AMENDMENT OF SOLICITATION/MODIFICATION OF CONTRACT			1. CONTRACT ID CODE	PAGE OF PAGES Page 1
2. AMENDMENT/MODIFICATION NO. Modification No. 001	3. EFFECTIVE DATE 24 Jan 2016	4. REQUISITION/PURCHASE REQ. NO. PR4895878-V2	5. PROJECT NO. <i>(If applicable)</i>

14. DESCRIPTION OF AMENDMENT/MODIFICATION <i>(Organized by UCF section headings, including solicitation/contract subject matter where feasible.)</i> THE PURPOSE OF THIS AMENDMENT IS TO INCLUDE CLAUSE 52.211.11 LIQUIDATED DAMAGES - SUPPLIES, SERVICES (SEP 2000), INCLUDE THE DETAILED SOW AND UPDATE THE SOLICITATION DUE DATE TO FEBRUARY 4, 2016				
Except as provided herein, all terms and conditions of the document referenced in Item 9A or 10A, as heretofore changed, remains unchanged and in full force and effect.				
15A. NAME AND TITLE OF SIGNER <i>(Type or print)</i>			16A. NAME OF CONTRACTING OFFICER Anthon W. Petty	
15B. NAME OF CONTRACTOR/OFFEROR		15C. DATE SIGNED	16B. UNITED STATES OF AMERICA BY  <i>(Signature of Contracting Officer)</i>	16C. DATE SIGNED
BY _____ <i>(Signature of person authorized to sign)</i>

SSA40016Q0003-A001: RSO Jeddah Health Unit Physical Security Upgrades

Medical Unit Upgrades

15-MINUTE FORCED ENTRY GRILLES

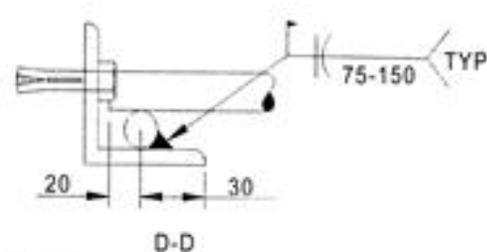
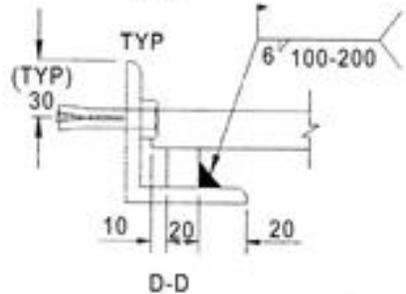
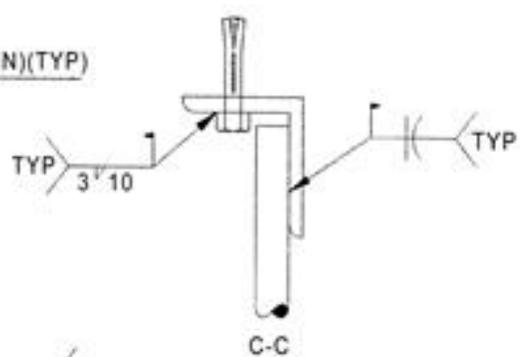
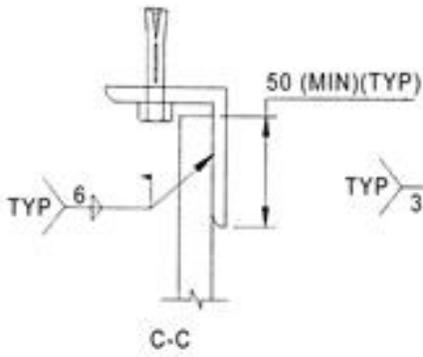
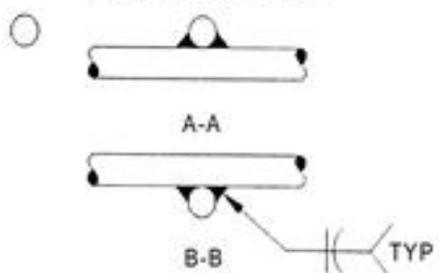
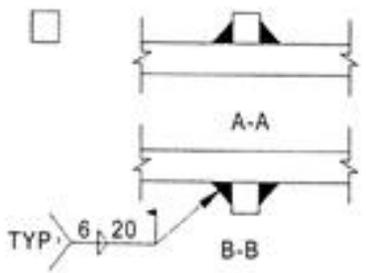
7.4 Contractor shall remove one existing window grille and permanently install custom 15 minute forced entry window grilles (based on include design plan) on the exterior of all identified windows (19 windows). Grilles shall be permanently affixed to the building's structural framing with screws and or spot welding as needed. Screws used to affix the grilles must be made tamper-proof either by design, peening, or welding. The window grilles shall be treated so they are weather and corrosion resistant. The grilles shall not obstruct the normal operation of the windows once installed. All 15-minute FE grille designs must be based on the following interim criteria (see below exhibit):

7.4.1 Minimum bar diameter - 3/4 in. (20 mm), or 1/2 in. x 3/4 in. (14 x 20 mm) rectangular bars;

7.4.2 Maximum horizontal spacing - 5 in. (125 mm);

7.4.3 Maximum vertical spacing - 5 in. (125 mm). All bolt heads must be welded to the steel frame. Additionally, surface mounted grilles must be designed such that they do not provide a convenient ladder (i.e. are anti-scaling). Forced entry window grille frames should be anchored using 3/8 in. x 3-1/2 in. (10 x 90 mm) (minimum) drop-in expansion anchors, 5 in. (125 mm) o.c. (maximum) for concrete, 3/8 in. - 16NC x 1 in. socket head cap screws at 5 in. (125 mm) o.c. for steel and 3/8 in. x 6 in. (10 x 150 mm) (minimum) Hilti C-20 or equivalent at 10 in. (250 mm) o.c. for masonry.
